**CITY OF SEATTLE  
ANALYSIS AND DECISION OF THE DIRECTOR OF  
THE DEPARTMENT OF PLANNING AND DEVELOPMENT**

**Project Number:** 3011964  
**Applicant Name:** Chris Davidson with Studio Meng Strazzara Architecture for  
GRE Greenwood Avenue LLC  
**Address of Proposal:** 8022 15th Avenue NW

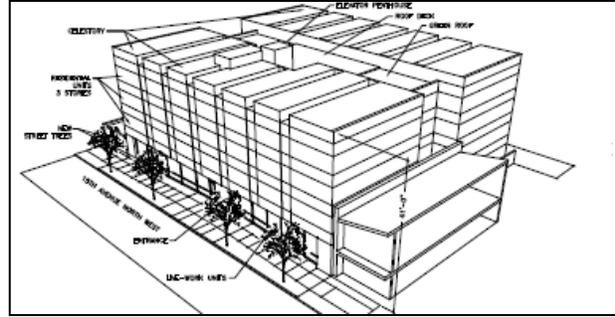
At the Final Recommendation Meeting, the Board did not discuss the inclusion of the guard rail grilles in front of sliding windows proposed for ventilation along 15<sup>th</sup> Avenue.

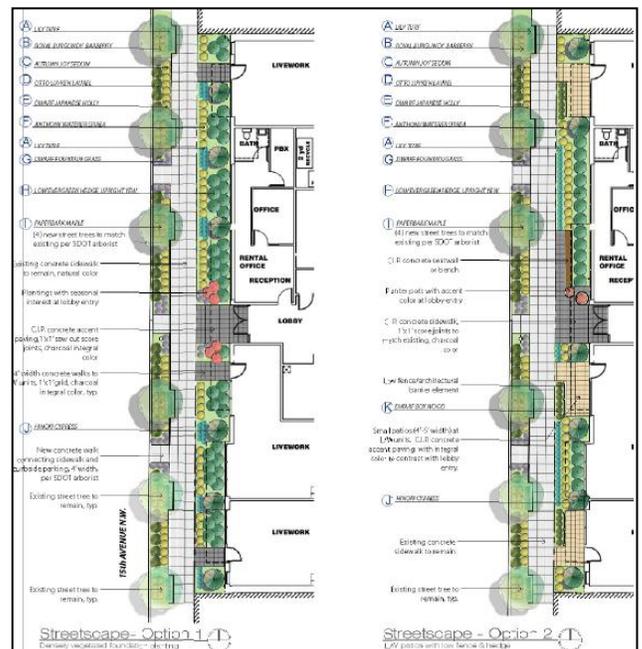
At the Early Design Guidance Meeting, the Board noted that appropriate lighting and mirrors should be considered and included in the alley design to allow for safe maneuvering of car to and from the site.

At the Final Recommendation Meeting, the Board was supportive of the exterior lighting plans which illuminate the ground areas of the building along 15<sup>th</sup> Avenue, as well as along the alley. The recommendations regarding the gate and fence design should also discourage graffiti from occurring at the alley.
